Permit of Authorization to Construct an On-Site Sewage Facility Permit Valid For One Year From Date Issued

Re: Favorable Assessment- Nonstandard Design Review for:
Jane B. Wood Family Partnership, LTD
2385 Bulverde Road, Bulverde, Comal County, Texas
OSSF Permit Application Number OSSF- 118461

RE: Septic Permit #118461
2385 Bulverde Road,
Bulverde, TX 78163
Jane B. Wood Family Partnership, LTD

Re: Unfavorable Review of Nonstandard OSSF Design for:
Jane B. Wood Family Partnership, LTD
2385 Bulverde Road, Bulverde, Comal County, Texas
OSSF Permit Application Number OSSF- 118461

DRIP TUBING SYSTEM**DESIGNED FOR:**

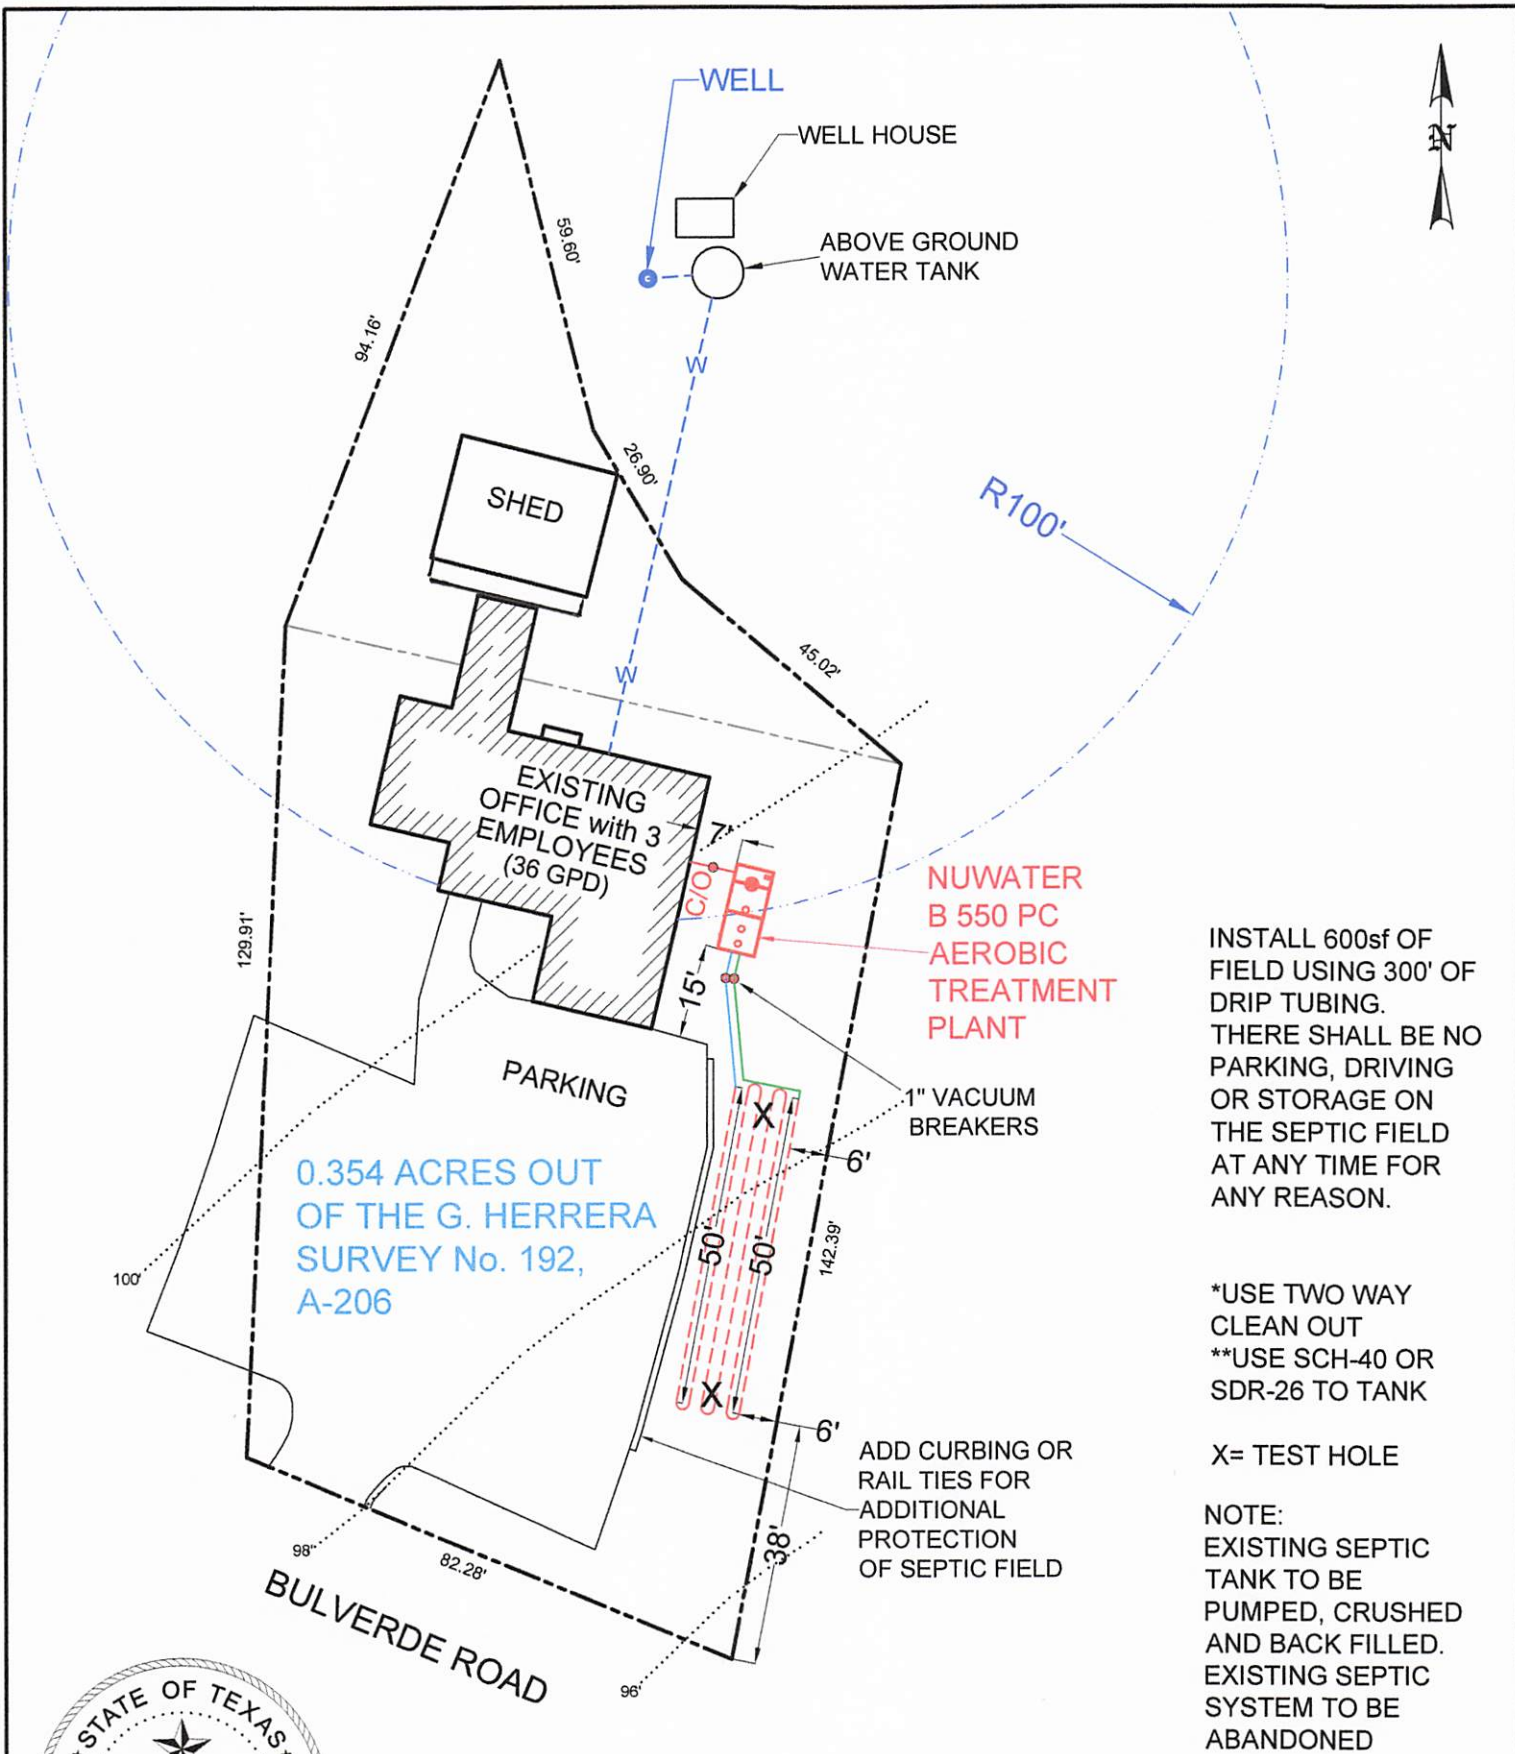
- Page 11 of 29, Total liner feet of drip tubing: 600 feet. Notation should be corrected.

- Page 11 of 29, Pump requirement: 300 emitters @0.61 gph @ 40 psi = 3.05 gpm. The notation should be corrected for 150 emitters in the field.

- Page 11 of 29, MINIMUM SCOUR VELOCITY section. The resulting MIN FLOW RATE is described as 3 gpm. The reviewer is not sure if this value is assuming two (2) 300-foot laterals for a field with 600 feet of tubing. Some clarification is needed.

Response: Typo on the writeup has been corrected to show 300 linear feet of drip tubing with 150 emitters for a total of 1.53 gpd

OWNER:	JANE B. WOOD FAMILY PARTNERSHIP, LTD.	DRAWN BY:	EJS III
STREET ADDRESS:	2385 BULVERDE ROAD		
LEGAL DESC:	G. HERRERA SURVEY No. 192, A-206	ACREAGE:	0.354
PREPARED BY:	GREG W. JOHNSON, P.E. F#002585	SCALE:	1"=30'
		DATE:	3/4/2025
		REVISED:

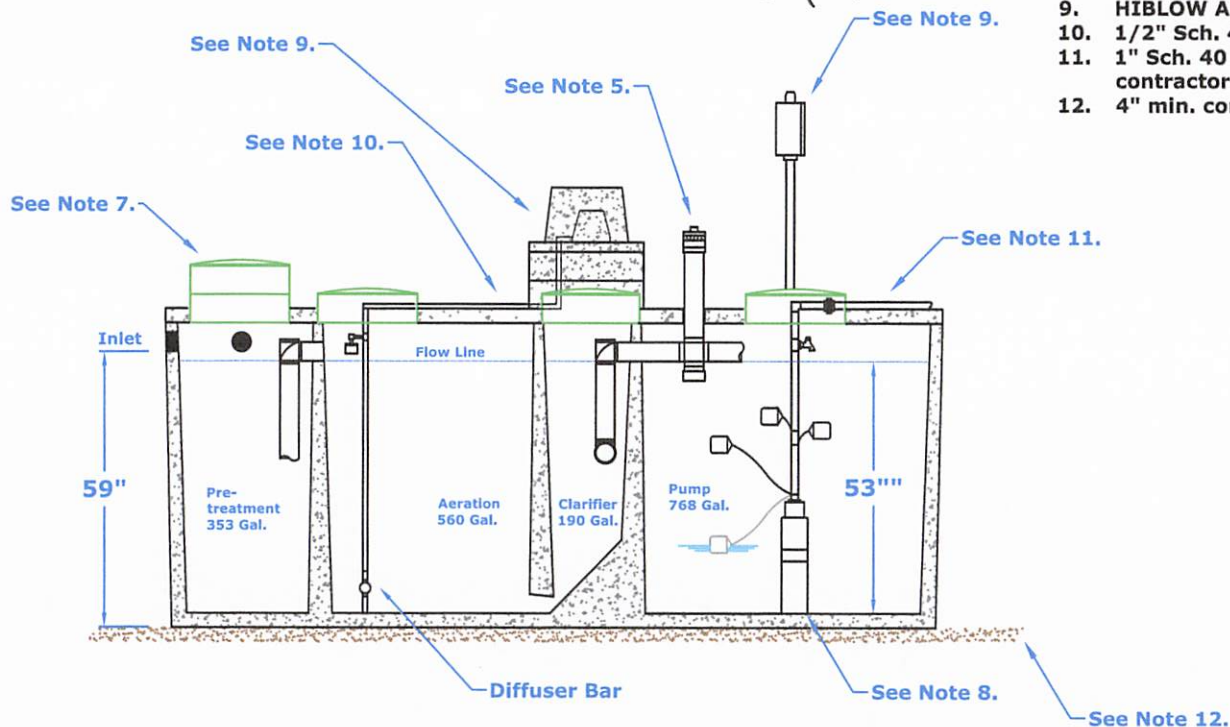
- Page 12 of 29, Drip field scaled drawing and notes indicate a total of 300 feet of drip tubing will be installed at the site. The drawing indicates six (6) fifty (50) foot tubing runs. The tubing runs are looped together to form a single lateral.
